Urgent Medical Device Correction - Immediate Action Required
iLab™ Polaris Systems

September 18, 2019

Boston Scientific (BSC) is initiating a voluntary correction of certain iLab Polaris Systems which were upgraded with a previous Polaris 2.10 software version (disk batch 629774). This letter provides instructions and recommendations to the user until a software upgrade (disk batch 636991) is completed.

iLab Polaris System Notice Instructions to Archive DFR Data

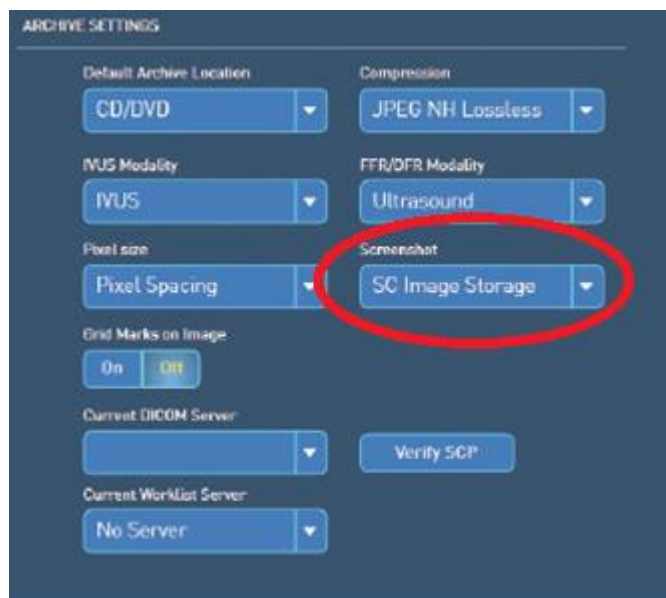
BSC has determined that due to a bug in the software disk batch 629774, **only the True Color SC format will archive DFR data as intended**. If either Multi-Frame US or SC Image Storage formats are used, the DFR data **will not be archived and the user will not be notified of this unexpected behavior**.

1. Select “**System Utilities**” from the “**Polaris**” drop down menu on top left of the screen.
2. As a User, in the “**Global Profile**” screen you can change the default archiving settings.
3. The “**Screenshot**” Field in “**ARCHIVE SETTINGS**” section is the one impacted by the issue described above.
4. Make sure to select the option “**True Color SC**”
